**TENTATIVE ORDER NO. R9-2010-0032, CITY OF ESCONDIDO HALE
AVENUE RESOURCE RECOVERY FACILITY (HARRF)**

In response to your letter dated May 3, 2010, the City of Escondido is submitting the following comments to the above referenced tentative order. Our comments and requested changes are in *bold italic*.

ATTACHMENT A – MAP

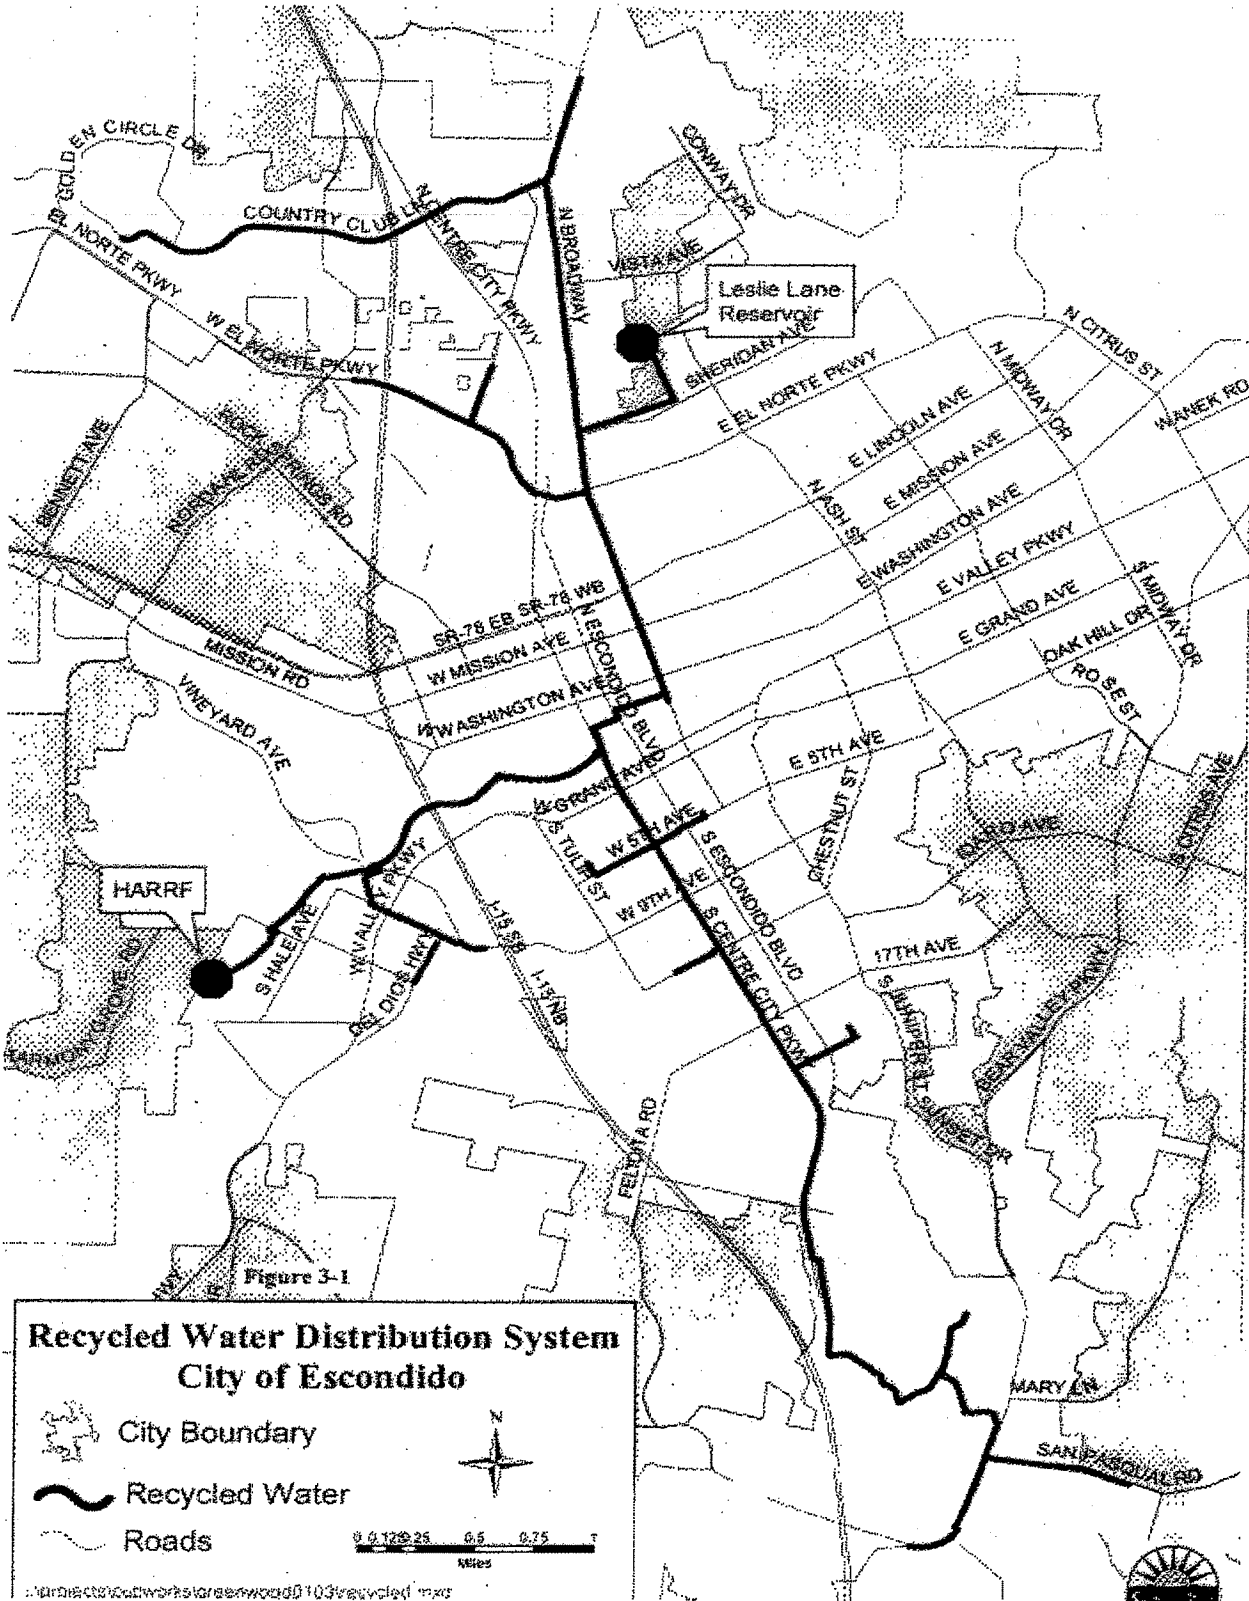
6. Attachment A, Pg. A-1

A revised map is enclosed. There has been one new line installed on Del Dios Highway.

Schematic of HARRF Treatment Processes

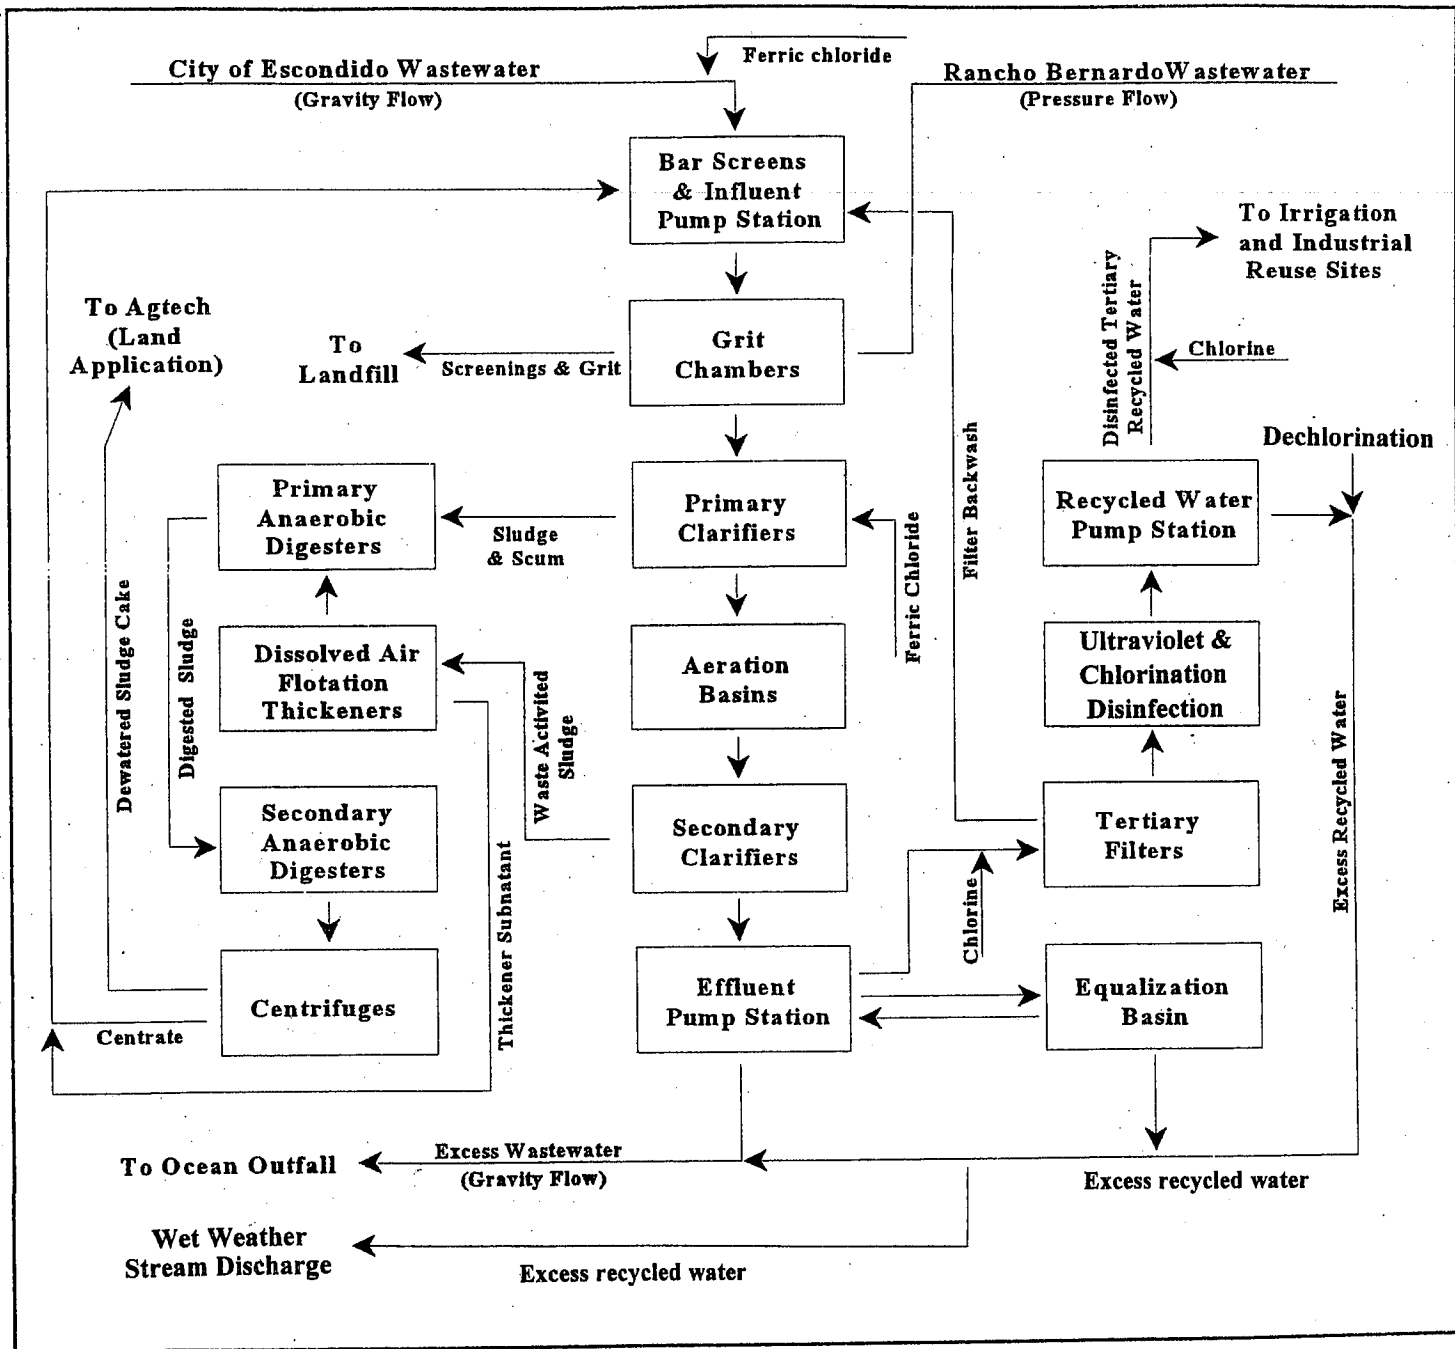
7. Attachment B – Flow Schematic

A revised schematic is enclosed.
